DONCASTER BEVERLY DANBURY RECONSTRUCTION

CITY PROJECT NO. 14079
CONTRACT NO. 8709

ADDENDUM #1- 5/17/2024
REVISED THE FOLLOWING:
TITLE SHEET
SHEETS G12-G15
SHEETS PD1-PD2, PD5-PD6
SHEETS P1-P2, P5-P6
SHEET U2-U6
REMOVED THE FOLLOWING:
SHEETS G12 AND G16

14079		U-3

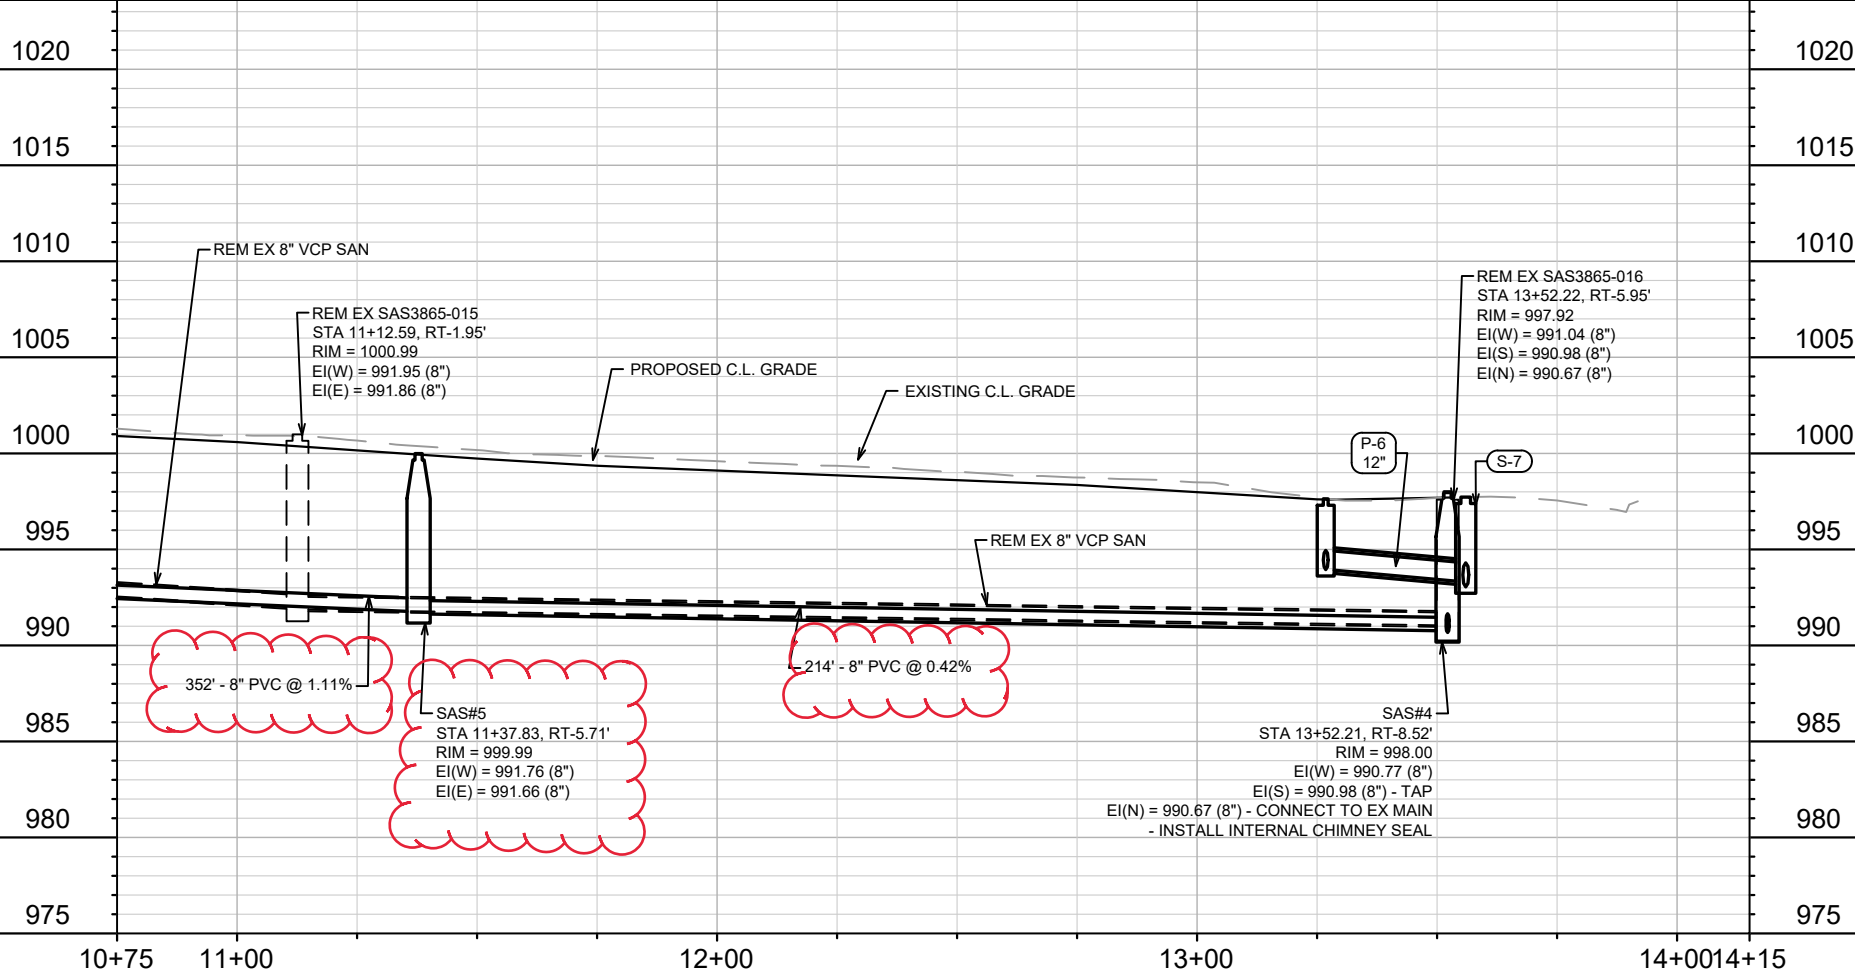
ADDENDUM NOTE:
 SHIFTED SAS#5 EAST TO AVOID
 GAS SERVICE. UPDATED LENGTH
 OF PIPE FROM SAS#5 TO SAS#6.
 UPDATED LENGTH OF PIPE FROM
 SAS#4 TO SAS#5.

MARK	REVISION	DATE	BY
AD#1	5/17/24	EKG	U-4
Designed By: MFG		Date: 5/17/2024 8:10 AM	Scale: 1" = 40'
14079		14079

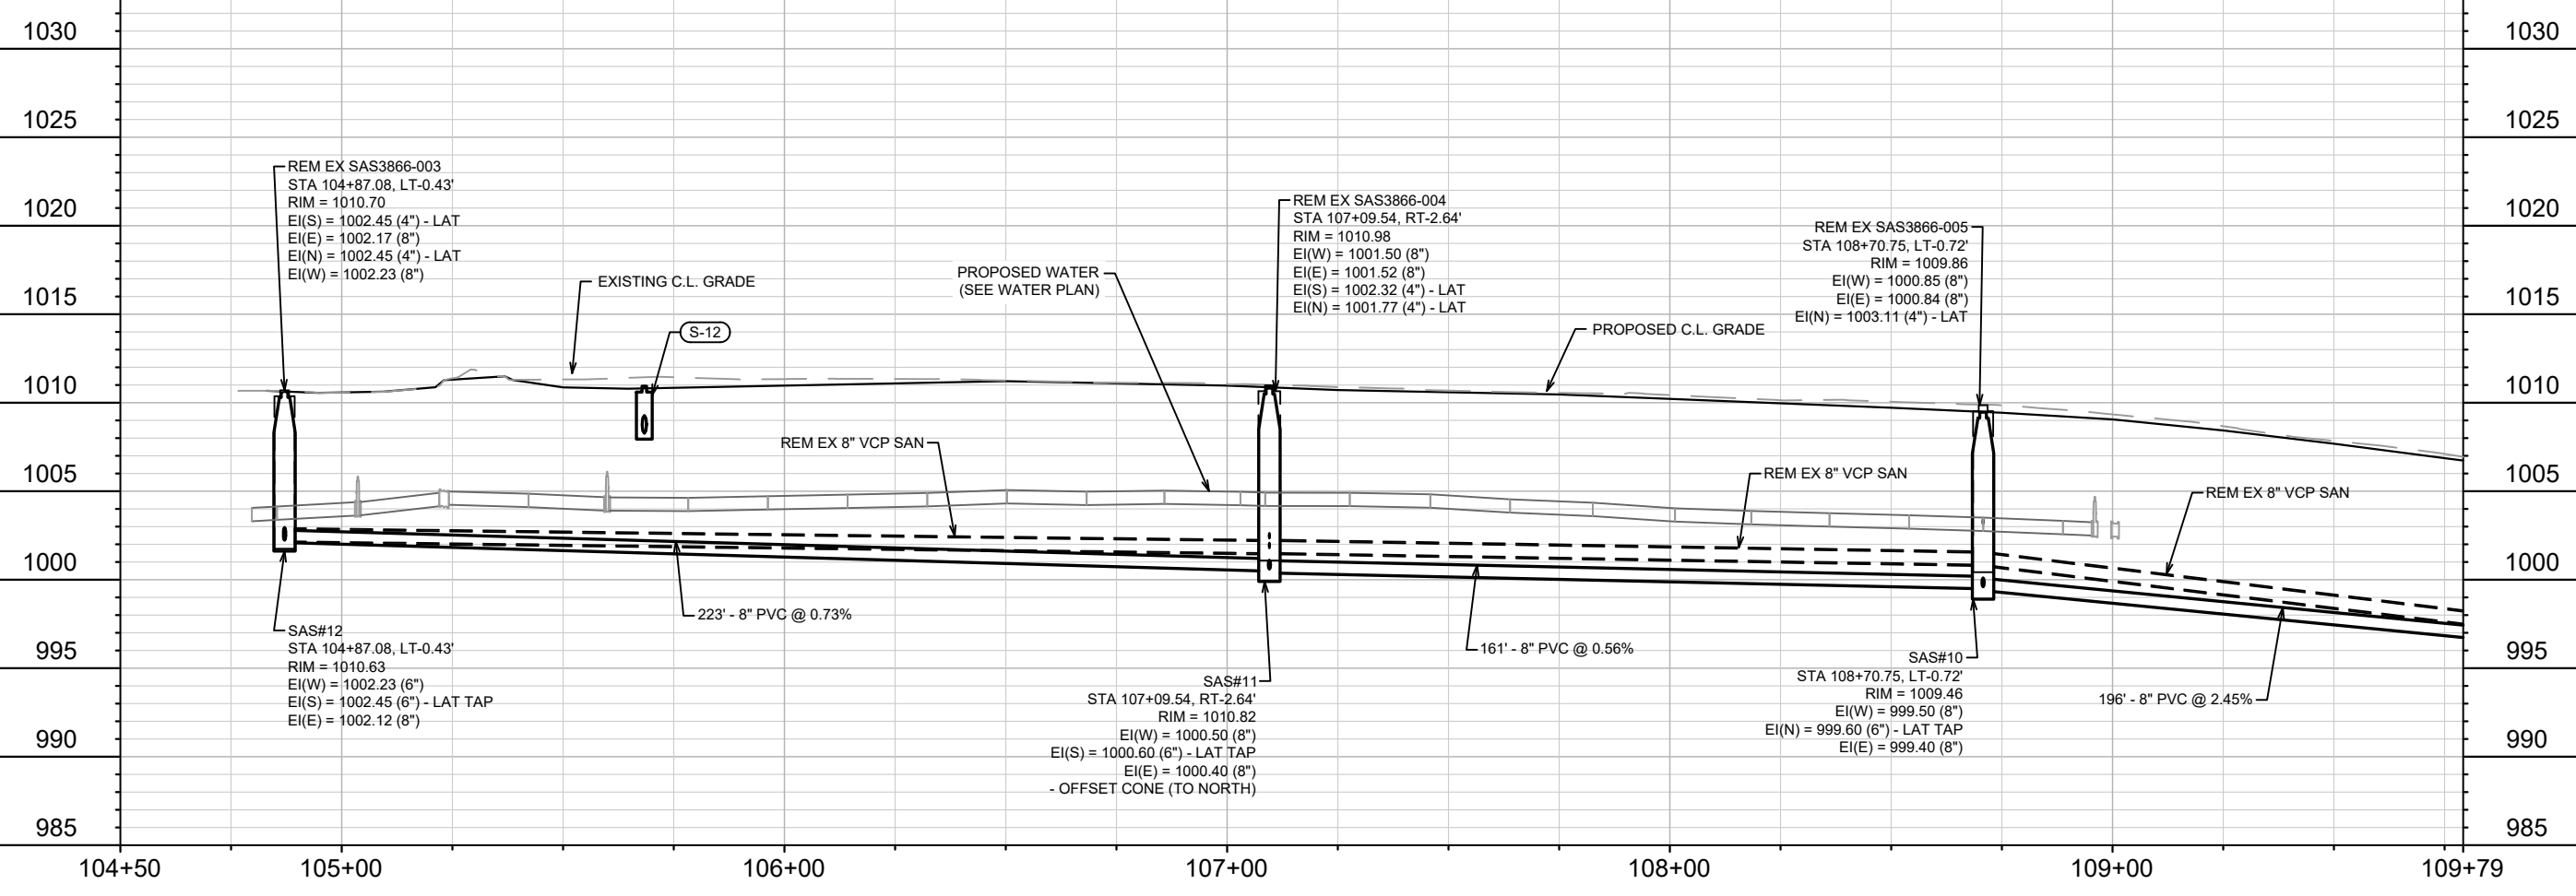
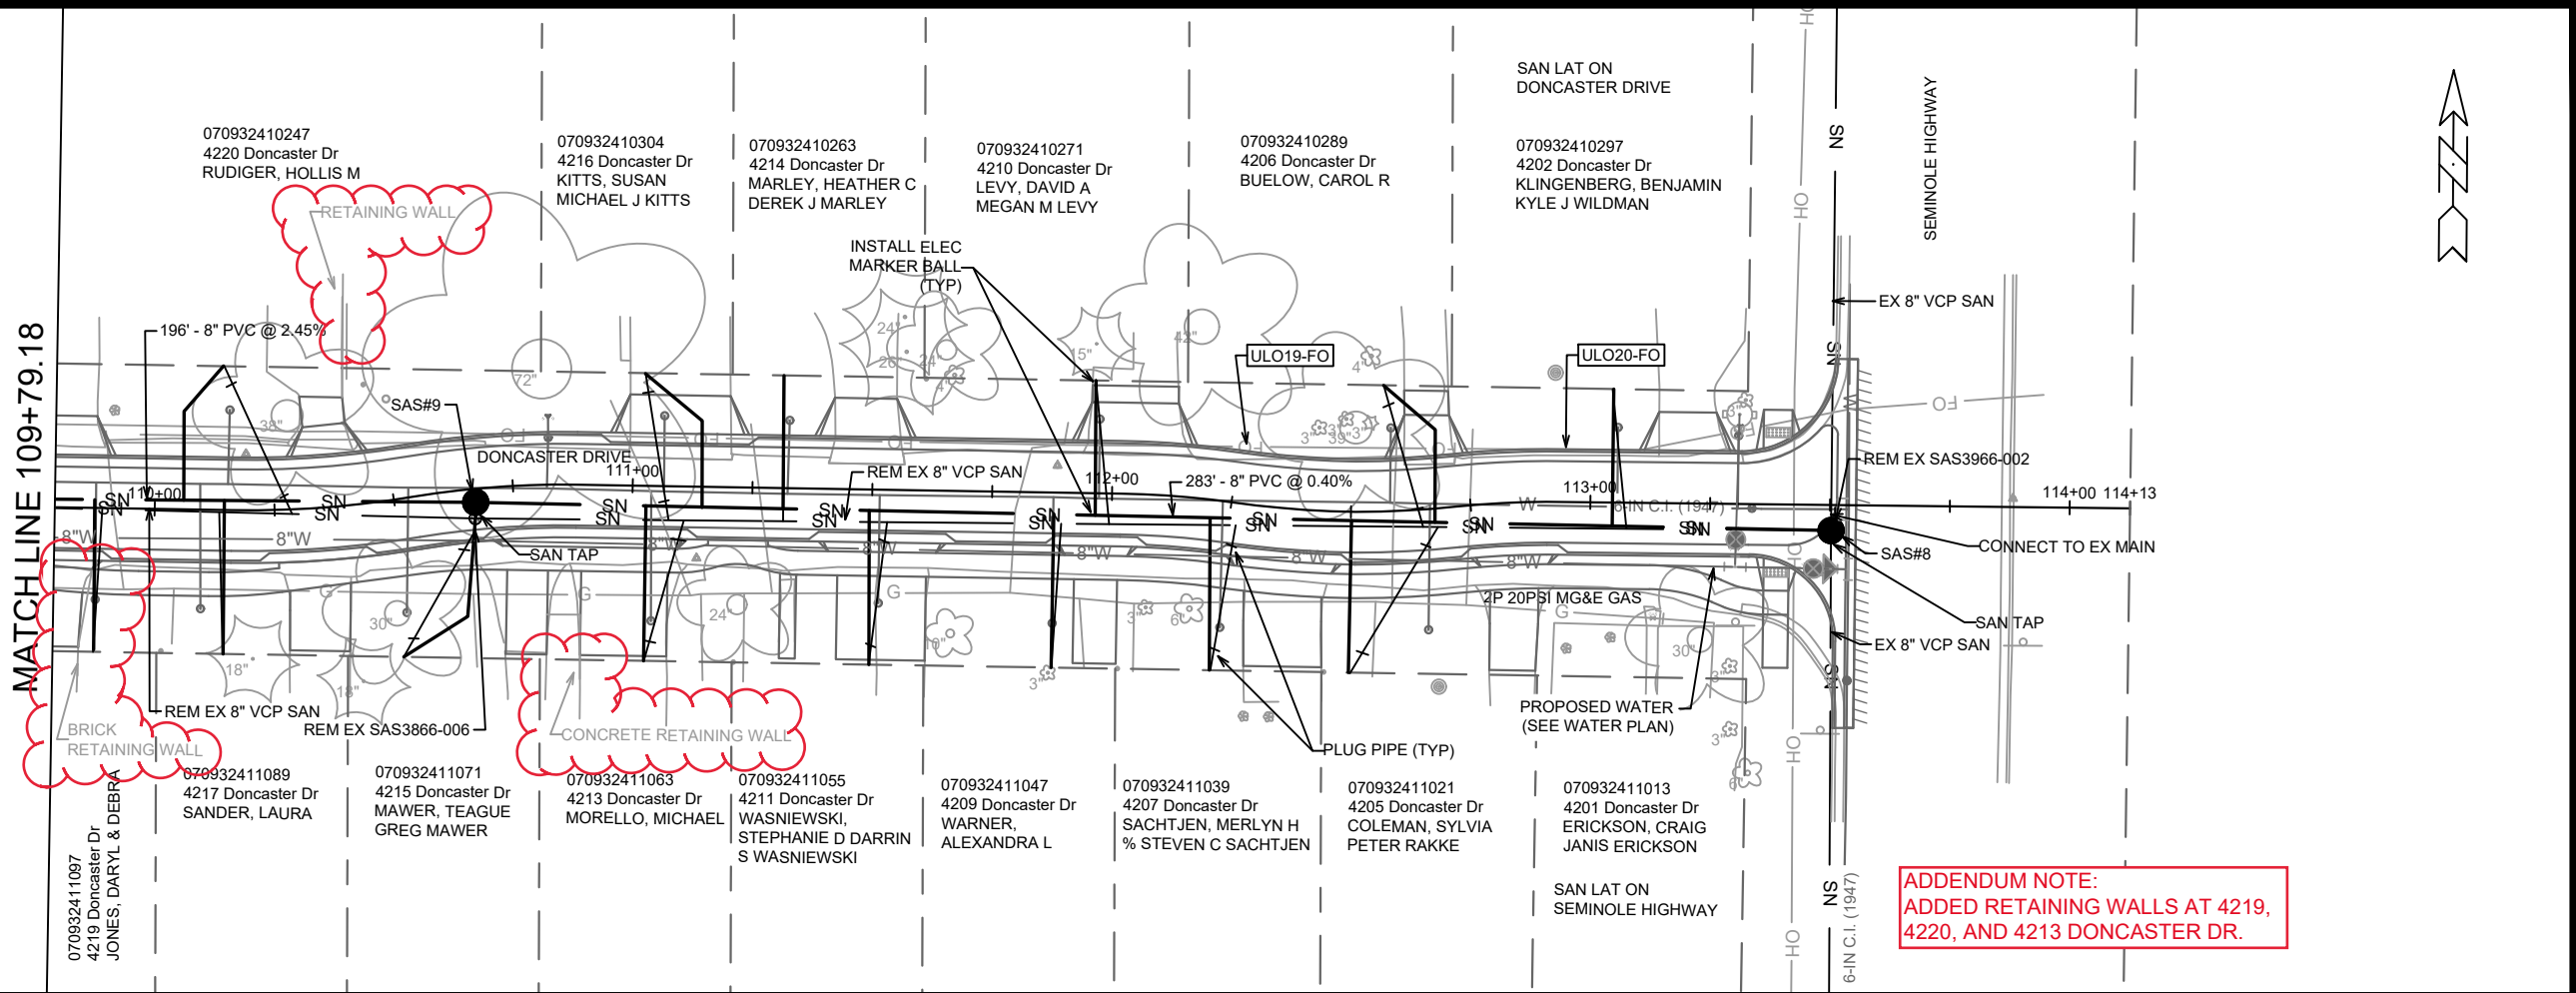
**ADDENDUM NOTE:
ADDED RETAINING WALLS AT 4228,
4226, AND 4222 DONCASTER DR**
